SOUTH CAROLINA STATE REGISTER

Volume 44 Issue No. 6

Document No. 4937
DEPARTMENT OF LABOR, LICENSING AND REGULATION
BUILDING CODES COUNCIL
CHAPTER 8
Statutory Authority: 1976 Code Sections 6-9-40 and 40-1-70

The South Carolina Building Codes Council proposes to amend Chapter 8, Article 8, to correct scrivener's errors in the modifications to the 2018 South Carolina Building Codes, the International Building Code.

FIGURE 307.2
MINIMUM FIXTURE CLEARANCES

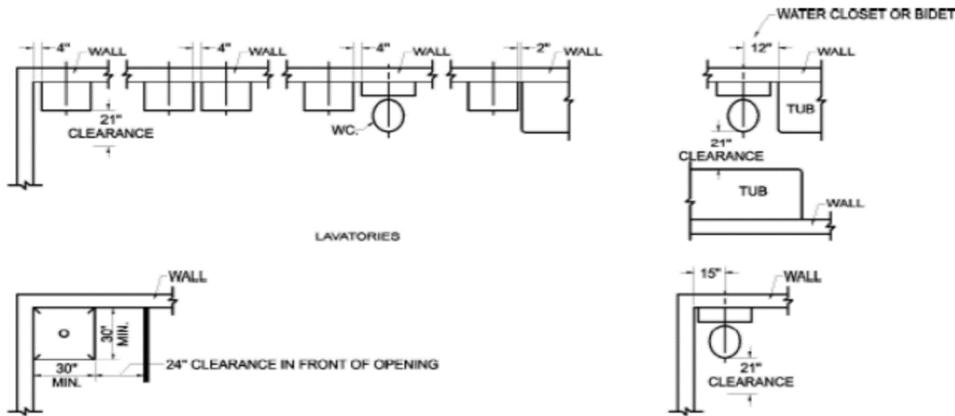
8-1206. IRC Figure R307.1 Minimum Fixture Clearances.
